Fiat 1.6 petrol engines / Synchronous Drive / Tensioner Info.

GATES REFERENCE:	5432XS and related kits.	
MAKE:	FIAT / LANCIA.	
MODEL:	Albea, Brava, Bravo, Dedra, Delta, Doblò, Lybra, Marea, Multipla, Palio, Siena, Stilo, Strada.	
MOTOR: MOTOR CODE:	1.6 petrol. 178B3000, 178C7098, 178D2011, 182A4000, 182A6000, 182B5098, 182B6000, 182B6000CNG, 182B6024, 185A3000, 186A3000CNG, 186A4000.

Technical Bulletin

Fig. 1

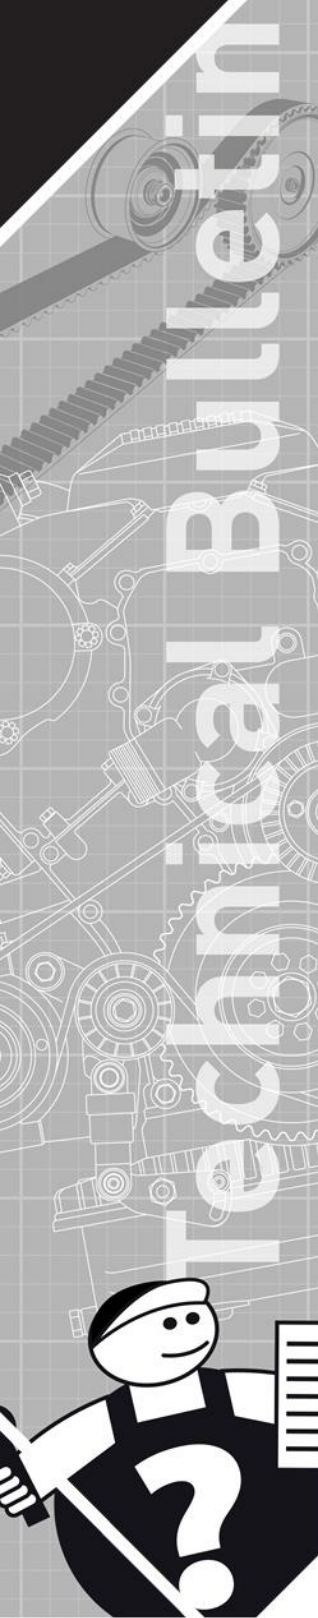
On OE(S) level the synchronous tensioner for these engines has changed already three times. Our kit has always reflected those changes in the course of the years. Since the latest evolution looks quite different to the previous one, we want to give this overview.

| Fig. 1 tensioner in kit until 08/2004 | OE ref. 46792898 |
| Fig. 2 tensioner in kit from 09/2004 until 11/2005 | OE ref. 46416489 |
| Fig. 3 tensioner in kit as of 12/2005 | OE ref. 71734799 |

The latest version that is now used on OE(S) level replaces the two previous parts.

It may be possible that the tensioner on the car is still an older model. There is no problem to install the latest version tensioner with the old stud and nut. Although the depth of the fixing hole (A) of the tensioner is deeper and the stud stays the same, there is still enough room on the stud to fix the nut properly, see Fig. 5 (B).

Fig. 4

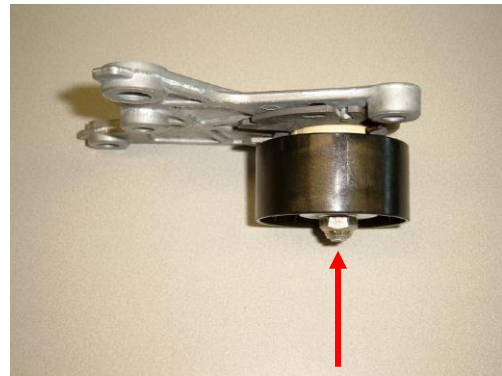
Fig. 4 and Fig. 5 show the latest version of the tensioner fixed on the bracket.

Normally this bracket (C) is mounted on the engine block and does not have to be removed.

Fig. 6

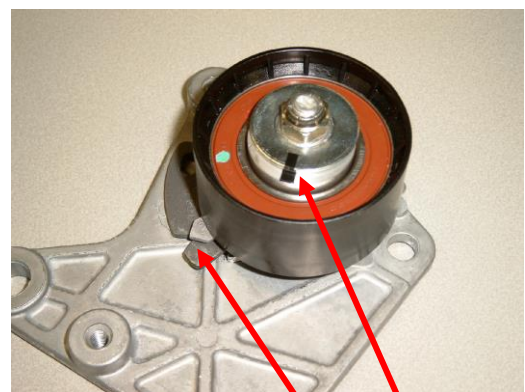
To lock the tensioner, position the open oblong hole in the base plate of the tensioner on the pin on the bracket (Fig. 6).

When the belt and the tensioner are replaced, following the installation instructions inserted in the kit, and after two engine revolutions, the pointer (D) has to be in the middle of the "V" in the base plate of the tensioner (E). At that moment the two black marks (F) will also be aligned. Only then the tensioner is correctly installed.

Fig. 8

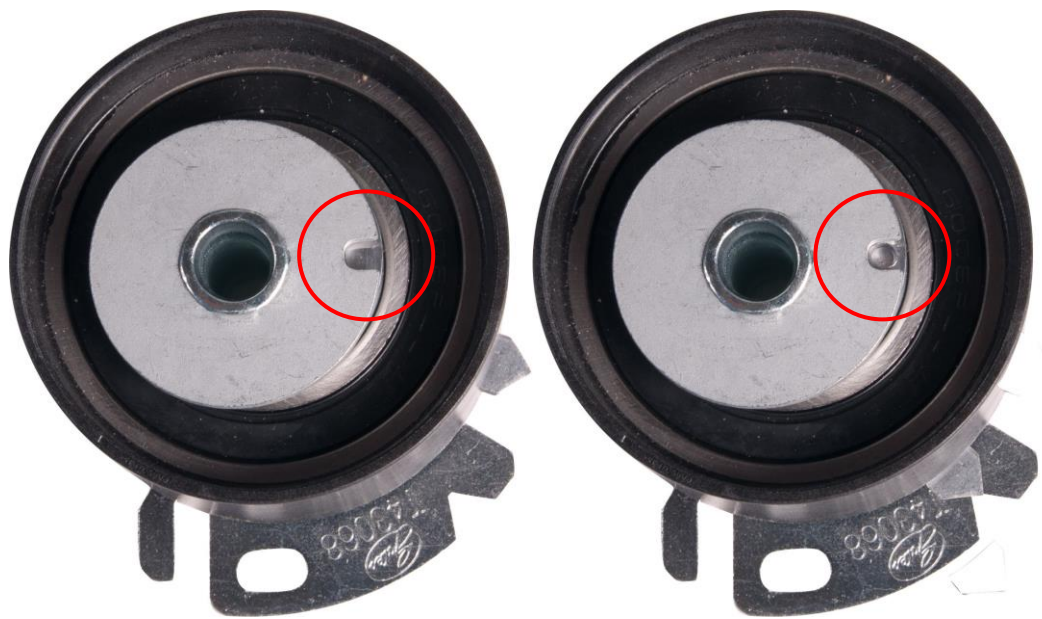
In the actual kits you find the tensioner (Fig. 8) on which we have changed the black marks into a new positioning system. The indicator of the correct position is a point in relief.

Not in the correct position:

In the correct position:
